Surplus Plutonium Disposition Final Environmental Impact Statement

Comment Response Document

Volume III - Part A

November 1999

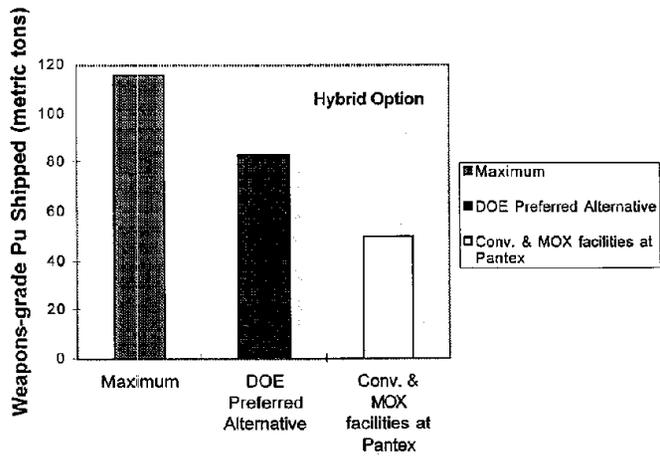
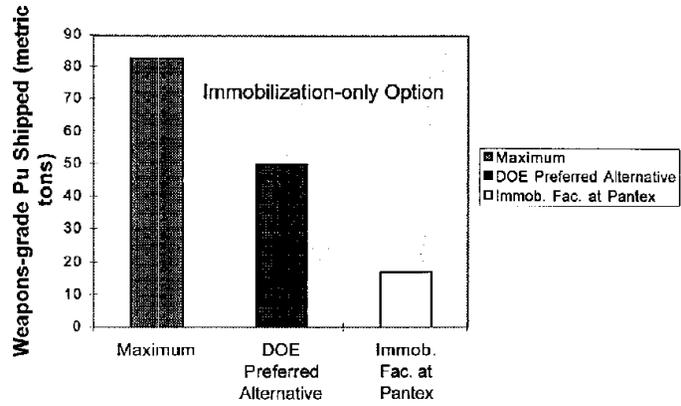
³ This assumes all surplus pits and clean metal selected for disposition already are stored at Pantex. On p. S-4 it is stipulated that “most of the surplus pits are currently located there” (i.e., at Pantex).
